DUKE POWER COMPANY
NUCLEAR PRODUCTION DEPARTMENT
 P.O. BOX 33189, 422 SOUTH CHURCH STREET
 CHARLOTTE, N.C. 28242
 (704) 373-4011

Subject: McGuire Nuclear Station
 Response to Questions Concerning
 Fire Suppression Pump 'C'

In response to your questions of September 10, 1985, the following information is provided:

MCGUIRE NUCLEAR STATION
 FIRE PUMP POWER SOURCES
 DWN. JAK DATE: 10/8/84

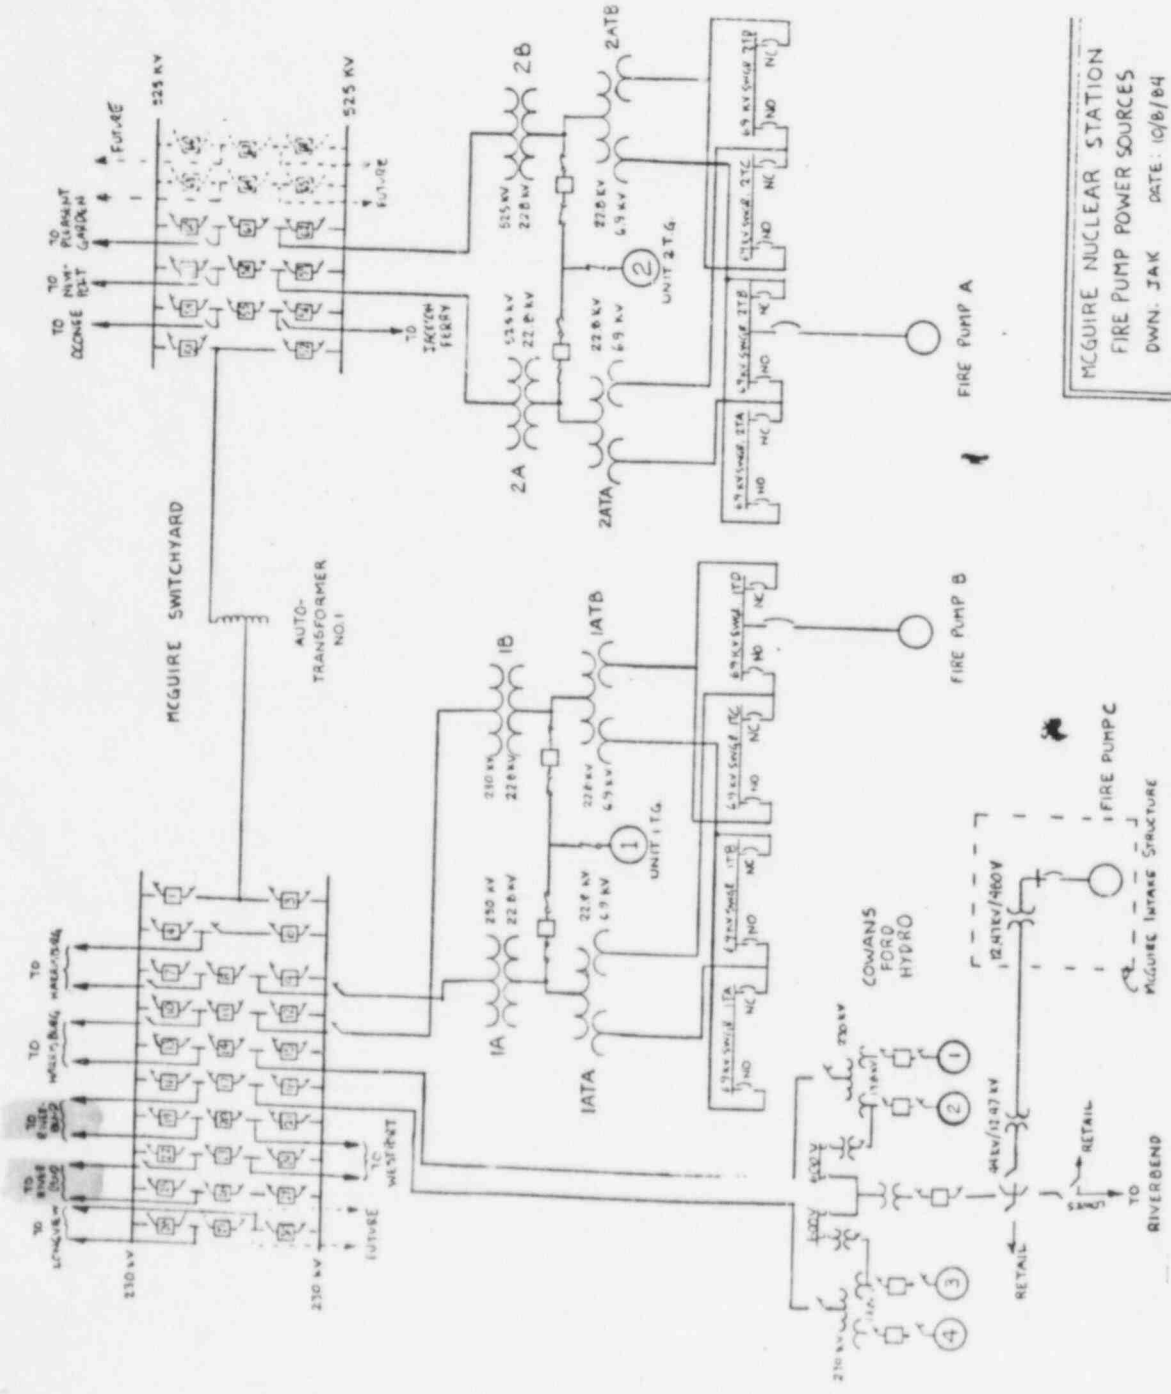
2. For fire suppression pump 'C', is the substation part of the grid or can it be separated from it?

Fire Suppression Pump C receives power from a 44KV substation fed from Riverbend Steam Plant Switchyard. There is no direct connection between the McGuire Switchyard and the 44KV System at Riverbend. The McGuire 525KV Switchyard has no direct tie to Riverbend, while the 230KV Switchyard is connected to Riverbend via the Schoonover and Norman Lines (see attached). At Riverbend, Units 6 and 7 feed the 230KV Switchyard through step-up transformers 6B and 7B.

The 44KV Switchyard is fed from the 100KV Switchyard through a tertiary winding on the step-up transformer for Units 1, 2, and 3 or through tie lines such as Mountain Island.

Under normal plant conditions, there is no tie between the 230KV Switchyard and the 44KV Switchyard at Riverbend. Units 6 and 7 have the capability to be aligned to the 100KV yard through alternate step-up transformers 6A and 7A; however, if this alignment is used, breakers to the 230KV Switchyard are opened and still no direct connection exists between the 230KV Switchyard and the 44KV Switchyard.

This isolation allows a total blackout of the McGuire Switchyard for any reason-fault, natural disaster, equipment failure, etc. to occur with no consequences to the 44KV feeder to Fire Suppression Pump C. Therefore, for any localized blackout situation at McGuire which would cause the loss of Fire Suppression Pumps A and B, Fire Suppression Pump C would still be available for service.
